Intersection ID: 13704	Main Street: CHESTERFIELD_AV	Cross Street: THE_PLAZA	Location:	E
ADA ID: AC1B1405600B	Ramp Type: PerpDiag	Initial Pass/Fail: Fail	Overall Compliance: No	Severity Score: 33.75

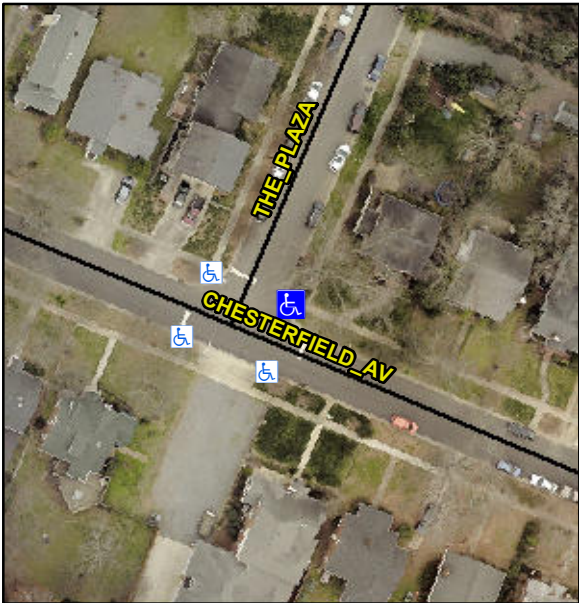
Codes/Mitigation Info/Possible Solution			Field Measurements/Component Compliance					
	Possible Solutions:		Compliance	Description	Data	Compliance	Description	Data
	<b>Remove &amp; Replace Curb Ramp With Two New Directional Ramps or Equivalent.</b>		N/A	Ramp Length (in)	55.0	No	Ramp Slope (%)	14.1
			No	Ramp Width (in)	45.5	Yes	Ramp XSlope (%)	0.5
			N/A	Flare Type LT	N/A	N/A	Flare Type RT	N/A
			N/A	Flare Slope LT (%)	N/A	N/A	Flare Slope RT (%)	N/A
			N/A	Flare Traversable LT?	N/A	N/A	Flare Traversable RT?	N/A
			N/A	Landing Length (in)	N/A	N/A	DWS Provided?	N/A
			N/A	Landing Width (in)	N/A	N/A	DWS Contrast?	N/A
			N/A	Landing Slope (%)	N/A	N/A	DWS Length (in)	N/A
			N/A	Landing X Slope (%)	N/A	N/A	DWS Full Width?	N/A
Surveyor Notes:		N/A	Landing Curb? (Y/N)	N/A	N/A	DWS Offset (in)	N/A	N/A
PROW/ADA:		N/A	Shared Landing?	N/A				
<b>Not Found, R304.5.1, R304.2.2</b>		N/A	Gutter Ponding?	N/A	N/A	Gutter Slope (%)	N/A	N/A

N/A	Gutter Lip Ht (in)	N/A	N/A	Gutter X Slope (%)	N/A	N/A
		N/A	Painted X Walk1?	No	N/A	Painted X Walk2?	No	No
			X Walk 1 Direction	To NW		X Walk 2 Direction	To SW	
		N/A	X Walk 1 Width (in)	N/A	N/A	X Walk 2 Width (in)	N/A	N/A
			X Walk 1 Slope (%)	3.7		X Walk 2 Slope (%)	1.2	
			X Walk 1 X Slope (%)	2.4		X Walk 2 X Slope (%)	2.8	
		N/A	Ramp inside XWalk1?	N/A	N/A	Ramp inside XWalk2?	N/A	N/A
			Road Slope (%)	2.7	N/A	Clear Space?	N/A	N/A
			Road X Slope (%)	3.5	N/A	Clear Space to XWalk (in)	N/A	N/A
		N/A	Any Obstructions?	N/A	N/A	Storm Grate/Utility Hazard?	N/A	N/A
			Obstruction Type			Storm Grate/Utility Type		
				N/A			N/A	N/A
					Yes	Surface Condition? (G/P)	Good	Good
Total Cost:		\$ 3200.00						
Street 1 Name		THE PLAZA						
Stop Condition-Street 2		StopSign						
Street 2 Name		CHESTERFIELD AV						
Stop Condition-Street 1		StopSign
